BLUE HERON DRIVE IMPROVEMENTS

PROJECT NO. BV01

1. *Replace Entire Bid Proposal Set with Attached set of Bid Proposal Alternate 2 and Alternate 3 were added to accommodate for a concrete pavement section.*
2. *The following specs have been added:*
 - a. *Spec 220*
 - b. *Spec 221*
 - c. *Spec 252*
 - d. *Spec 360*

NO.	REVISIONS	DATE	NAME
1	1/5 FOR ALTERNATE CONCRETE PAVEMENT	10/14/20	PHF
ADDITION # 1

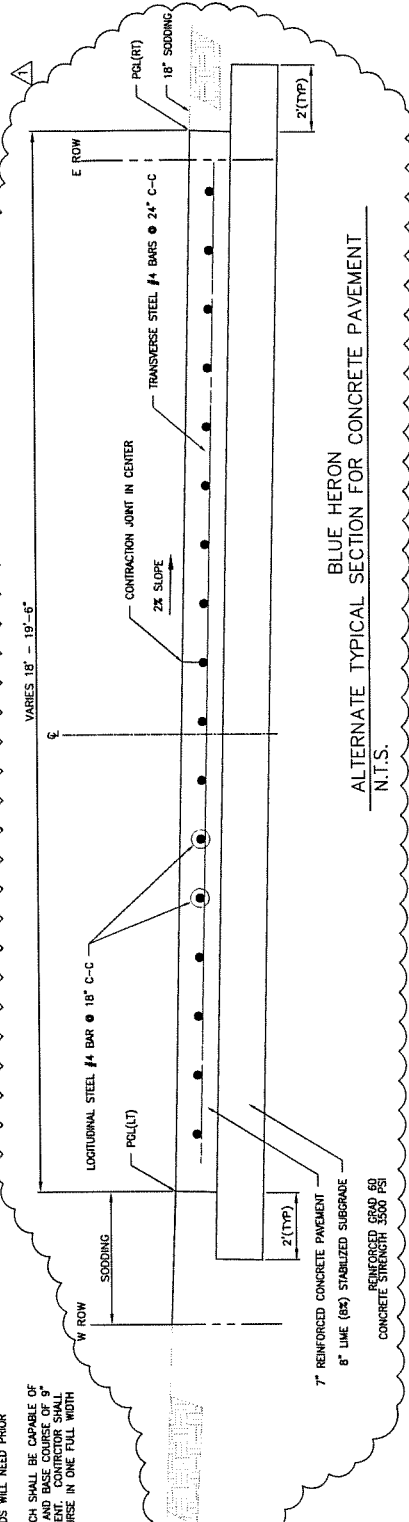
1. *Sheet No. 2 - Added Alternate Typical Section for Concrete pavement*
2. *Sheet No. 4 - Replaced call outs for '9" cold-in-place black base' with '9" cold-in-place recycled base.*
